## **South Lincolnshire Reservoir and Anglian to Affinity Transfer**

### **Proposed Scope Changes to SROs at gate two**

**Supporting note to gate two submissions 14<sup>th</sup> November 2022**

**Figure 1 – Proposed scope changes at Gateway 2 for SLR and A2AT SROs**

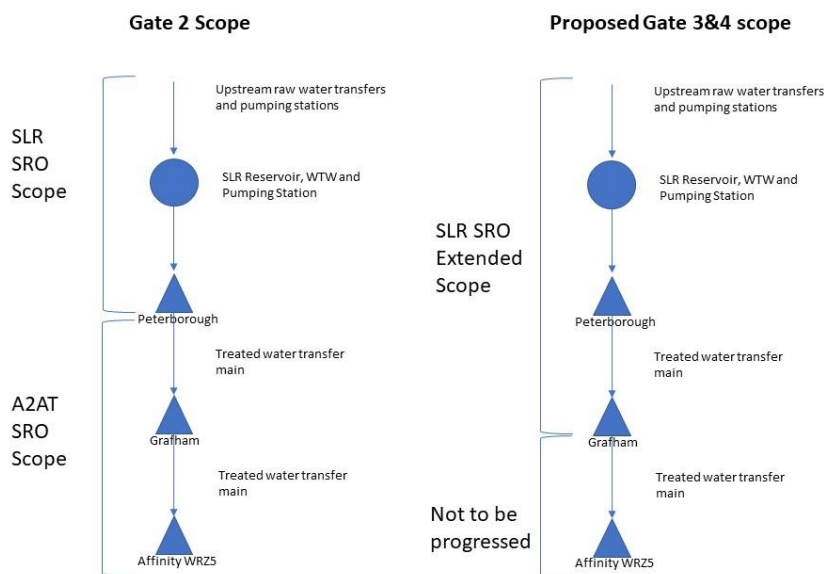
As the Affinity water draft WRMP does not select the A2AT, it is proposed that the scope of both (a) the entirety of the Eastern route and (b) the Western route from Grafham into the Affinity region is not progressed beyond gate two.

Currently the scope of the SLR SRO includes a transfer to Peterborough in the Anglian Water region. Peterborough was likewise the source/starting point of the A2AT SRO. However, as Anglian Water has identified the need for the water to be transferred further south into the Ruthamford region and specifically to Grafham, it is proposed that the scope of the SLR SRO is extended to include a transfer, or transfers, further into the Ruthamford region, including to Grafham. This scope extension would include further investigation of the Peterborough to Grafham section (or “northern section”) of the A2AT Western route that has been progressed to gate two.

It is proposed that Option 1 is followed, i.e. the northern section (as far as Grafham) is merged into the SLR scope and jointly progressed as a single SRO. This is in preference to A2AT being progressed as a separate SRO, or to incorporating the de-scoped version of A2AT into the next Business Plan. As

SRO	Scope developed to gate two	Scope proposed for gates three and four and into delivery
<b>SLR</b>	<ul style="list-style-type: none"> <li>Raw water transfer, pumping and INNS treatment from River Trent to River Witham</li> <li>Raw water transfer and pumping stations from River Witham to reservoir</li> <li>50Mm3 (of useable volume) raw water storage reservoir</li> <li>WTW and treated water pumping station</li> <li>150 MI/d treated water transfer to Peterborough</li> </ul>	<ul style="list-style-type: none"> <li>Raw water transfer, pumping and INNS treatment from River Trent to River Witham</li> <li>Raw water transfer and pumping stations from River Witham to reservoir</li> <li>50Mm3 (of useable volume) raw water storage reservoir</li> <li>WTW and treated water pumping station</li> <li>150 MI/d Treated water transfer to Peterborough</li> <li><b>Additional treated transfer from Peterborough to Grafham</b></li> </ul>

<b>A2AT</b>	<ul style="list-style-type: none"> <li>Treated water transfer from Peterborough to Affinity Water Resource Zone 5 (WRZ5). 50 ML/d, 100 ML/d and 150 MI/d (Peterborough to Grafham only) assessed.</li> <li>WTW in Affinity Water’s WRZ5</li> </ul>	None – proposed no further work is undertaken past Gateway 2.
